## ST 1 RSA -- MONAGHAN CIVIC OFFICES DBFL

# 1.0 Introduction

This report was prepared in response to a request from Mr. John Carr, DBFL Consulting Engineers, for a Stage 1 Road Safety Audit for the proposed road and active travel links being part of an overall scheme for Monaghan County Council's new civic offices.

Drawing 220084-RY-04-Z00-XXX-DR-DBFL-CE-1001 Rev 0 and 1002 rev 0, GAA grounds.

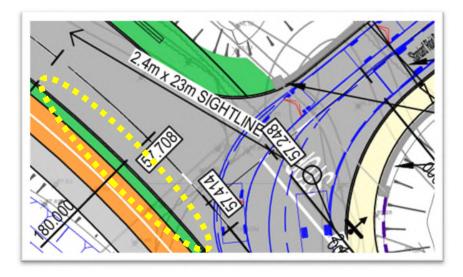
There is a risk that during high attendance fixtures at the GAA grounds that drivers will park on the verge and partially on the two-way cycle track thereby blocking the route for cyclists and leading to possible collisions with opening doors. Parking may also occur on the swale side of the new road.

It is recommended that preventative measures be provided to avoid parking overspill from the GAA grounds.
